TOWN OF MORAGA PLANNING COMMISSION MEETING

March 7, 2011

- A. CDP 02-05 - Draft Environmental Impact Report for the Hetfield Estates Subdivision, John Wyro (Applicant), Robert and Sandy Lipson and Sanford Gage (Property Owners):** Public Hearing to receive comments on the Draft Environmental Impact Report (EIR) for the proposed 7-acre lot subdivision. The project being evaluated by this EIR is the subdivision of a 58.2-acre parcel into seven lots. Six single-family lots would be located on 6.75 acres, with the remaining lot containing 51.45 acres that would remain in permanent open space. The open space area would be maintained either by a homeowner's association or a special district, e.g., geological hazard abatement district (GHAD). The six residential lots would range in size from 41,826 square feet (.96 acre) to 59,930 square feet (1.38 acres). The proposed development is located on a northern portion of a remnant parcel that was previously subdivided in 2001 (Subdivision 8444). At that time, the entire parcel contained 65.5 acres and 7.4 acres were developed for single-family housing in the southwest corner of the property.

Town of Moraga
Planning Commission Meeting Minute

Figure 3.2-4 Geologic Cross Section L-1

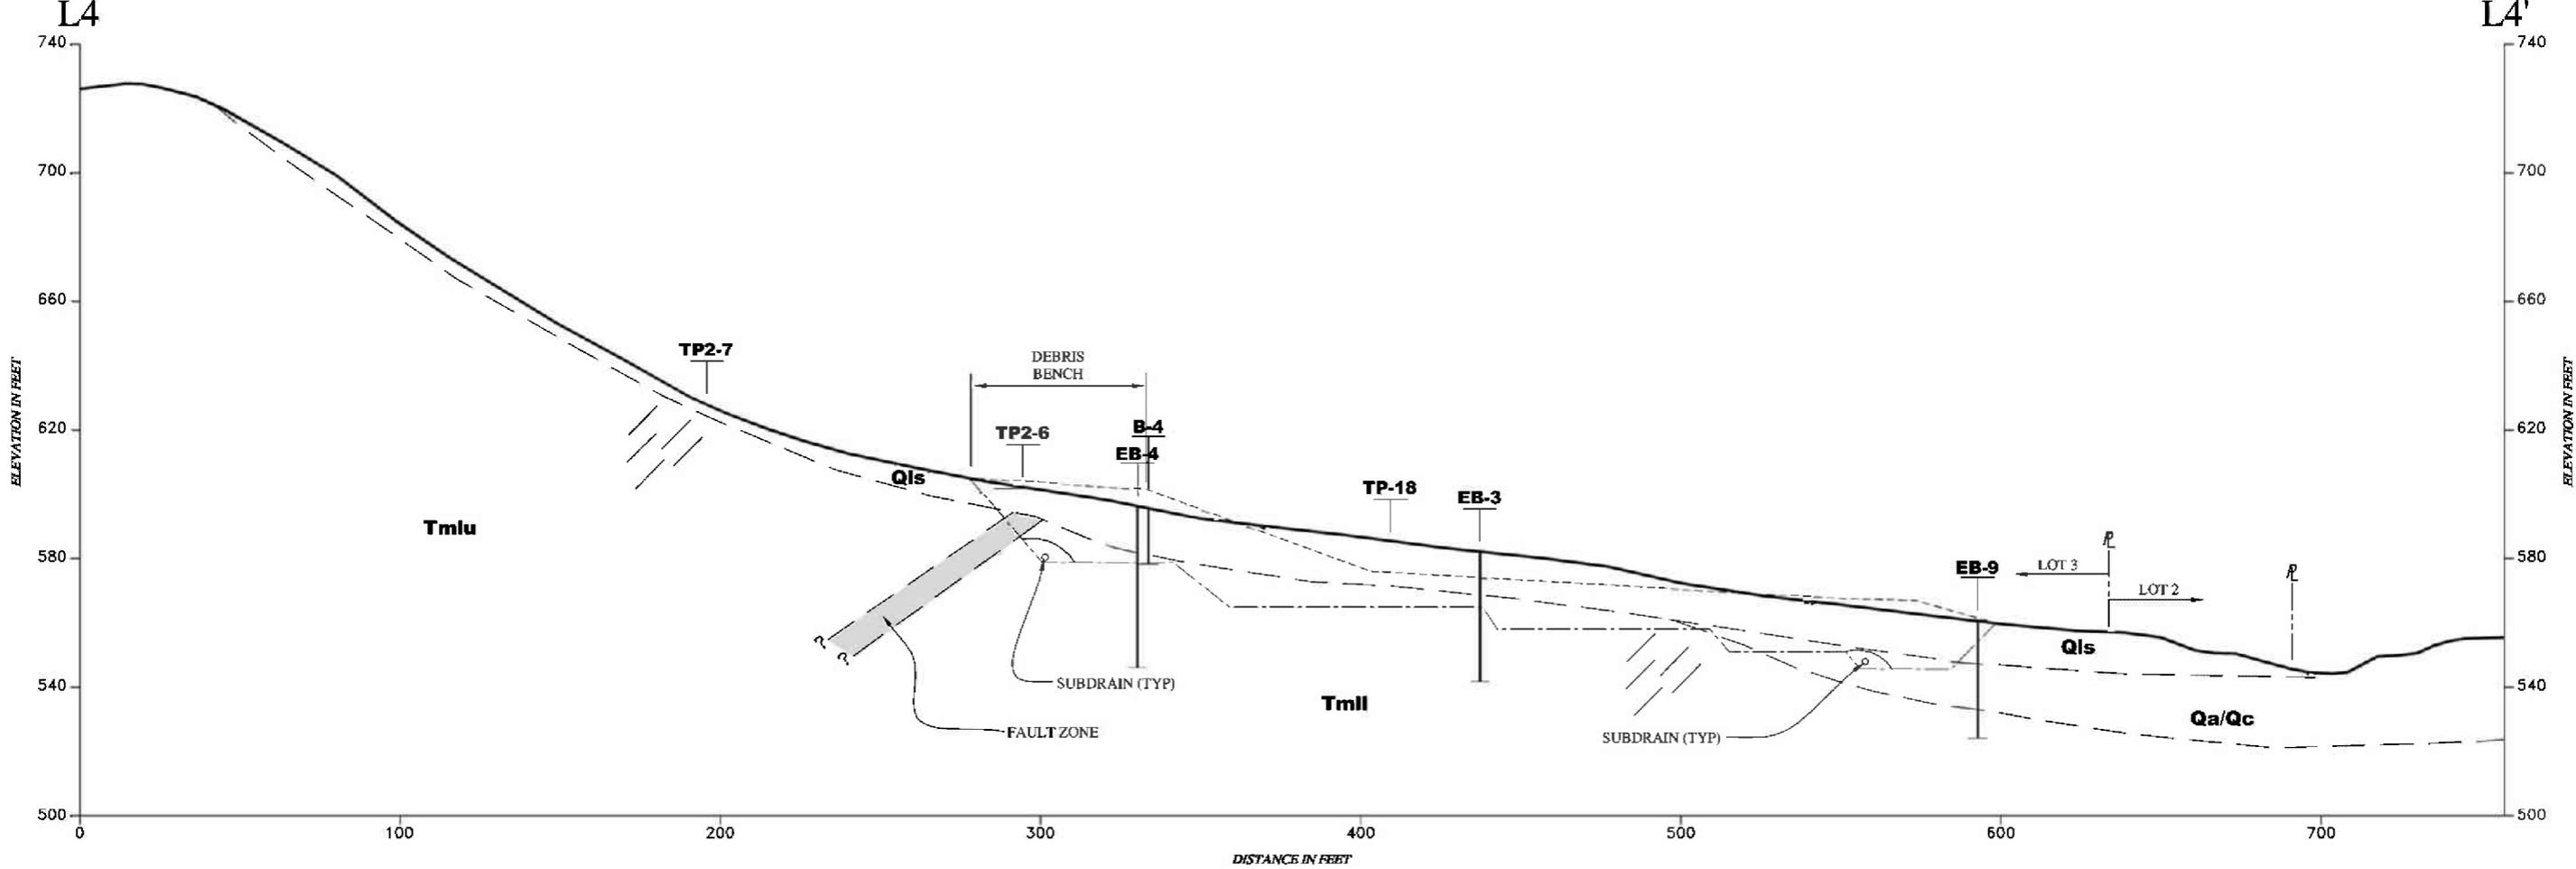
- M-30 **Comment:** Requested that Figures 3.2-4 and 3.2-5 be enlarged.

Response: DEIR Figures 3.2-4 and 3.2-5 have been enlarged and are included on the following pages.
